Comments on Revised Noise Impact Study

*Re: Independent Peer Review of the Revised Noise Impact Study for the
Saddleback Ridge Wind Project*

Re: *Remand for Saddleback Ridge Wind, LLC, L-25137-24-A-
N/L-25137-TG-B-H (Approval)- Comments of Appellants
Friends of Maine's Mountains et al. on Revised Noise Report*

Subject: Comments on the Peer Review by Peter Guldberg of Tech Environmental
 Saddleback Ridge Wind Farm, Carthage, Maine. RSG, Inc. Revised April 2013

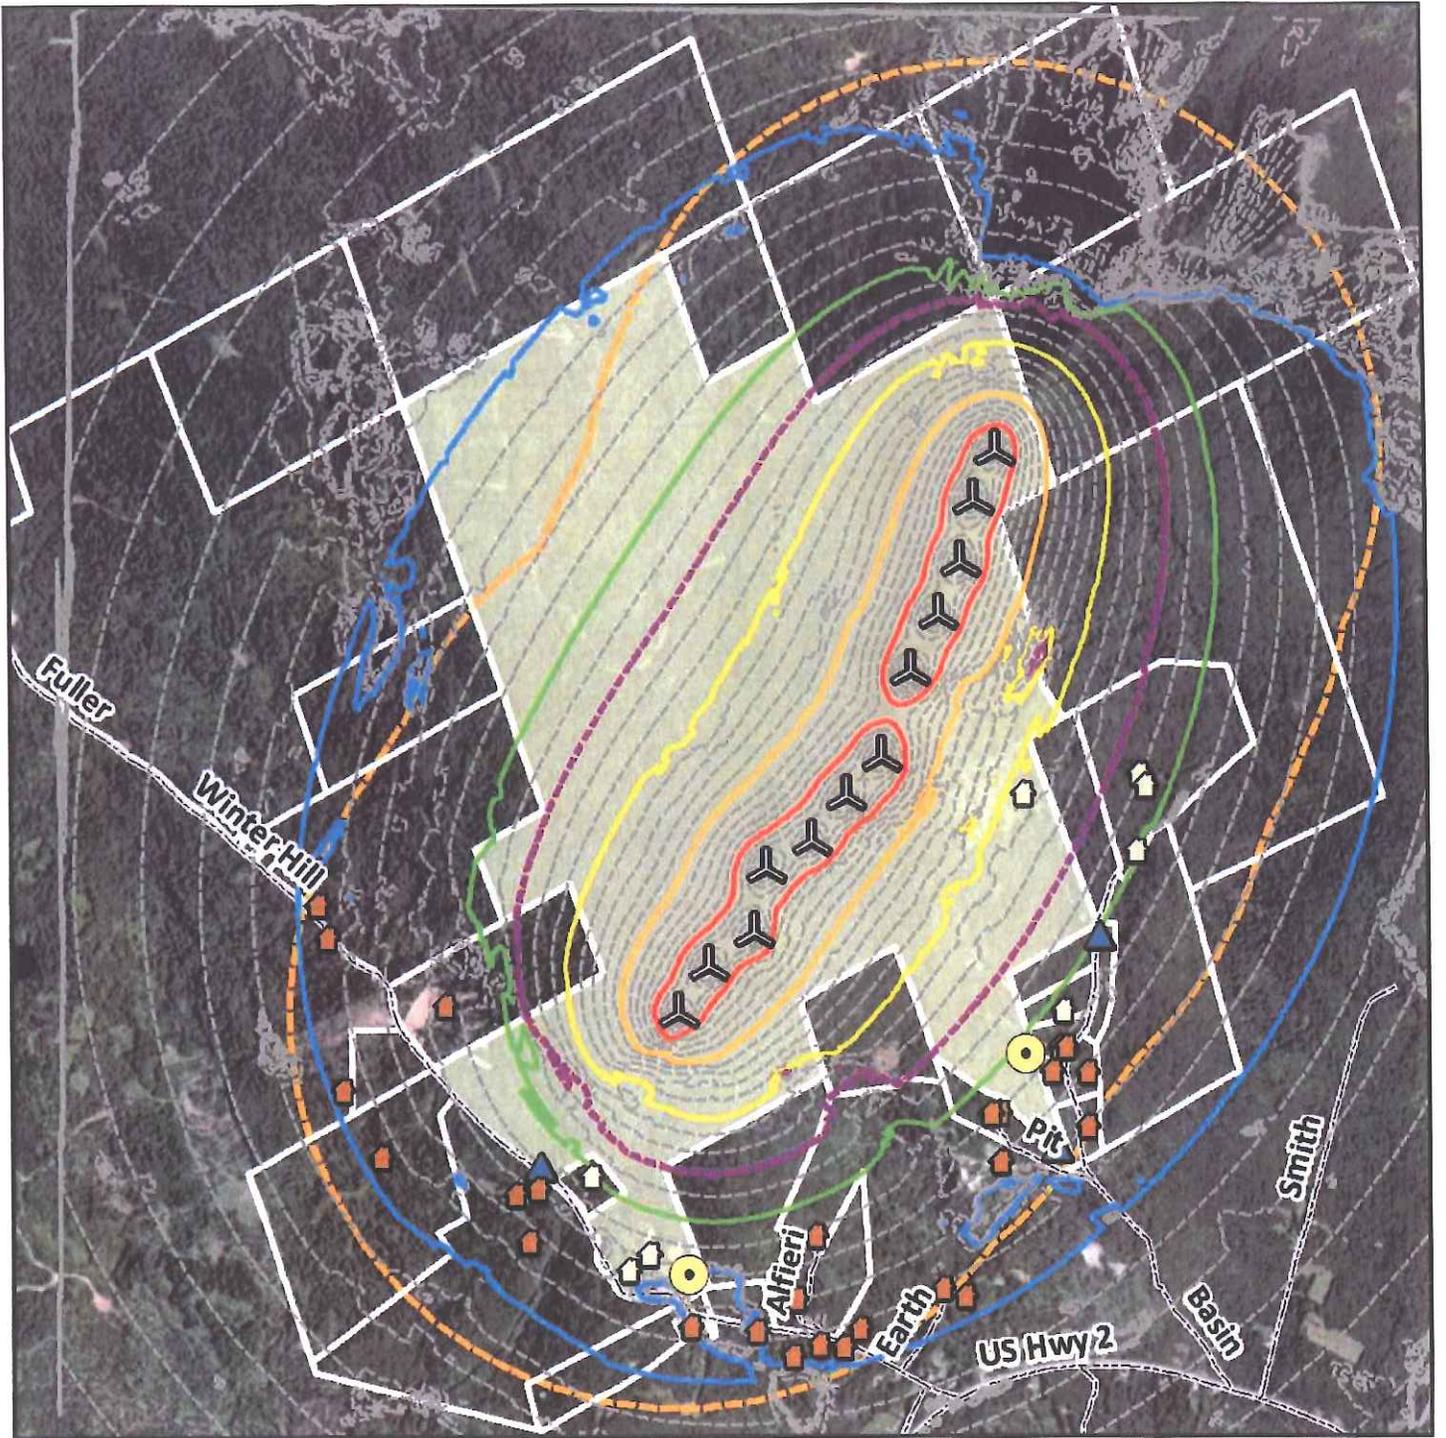
5) Appellants' claim that, based on measurements taken by appellants at Mars Hill, SRW's modeling using updated GE sound power curves was flawed. (Ambrose and Rand at 20-21.)

Response: The appellants make an argument that the modeling conducted by the applicant is not consistent with their measurement of attenuation from a completely different wind farm, Mars Hill. The Mars Hill project has more than twice as many turbines and tighter turbine spacing. While the appellants' approach is novel, it is an "apples to oranges" comparison and not consistent with the requirements of Chapter 375(10), which require site-specific parameters when preparing predictive modeling estimates of sound levels.
